# **Intel<sup>®</sup> Communications Chipset 89xx Series**

**Specification Update**

*October 2012*

**Document Number: 328000-001US**

**Figure 2. 1000BASE-BX/FC-PI Transmitter Electrical Specifications**

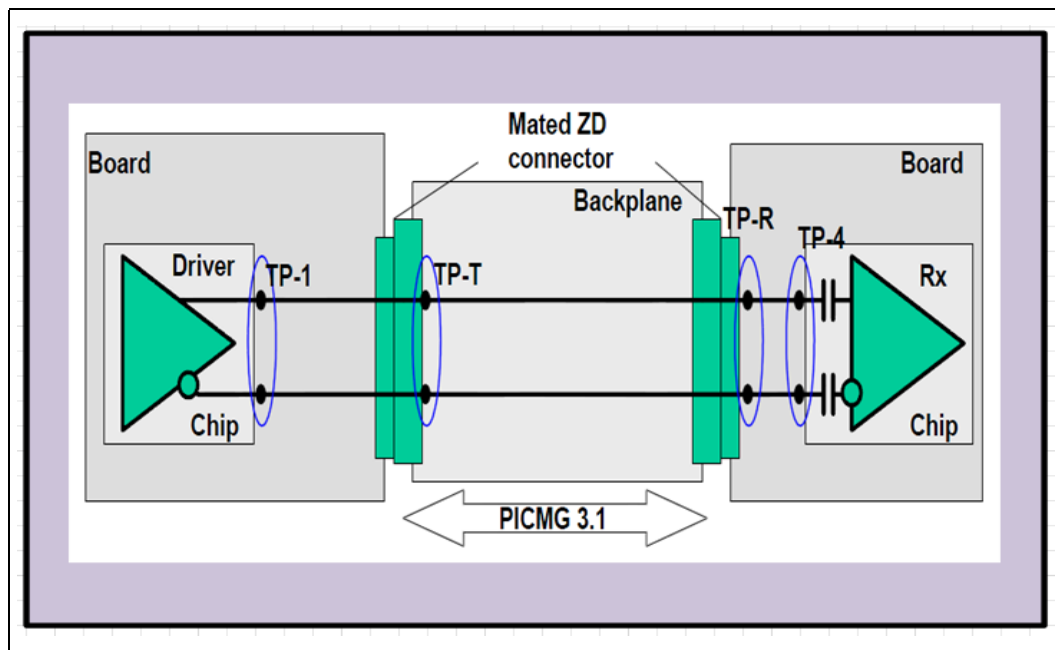
**Implication:** Although this is a specification violation, it does not affect the functional operation of the interface.

**Workaround:** Ensure that the signal routing length from TP-1 to TP-4 is greater than 10". Refer to Intel® Communications Chipset 89xx Series Platform Design Guide (PDG) for maximum routing length. (See Figure 2).
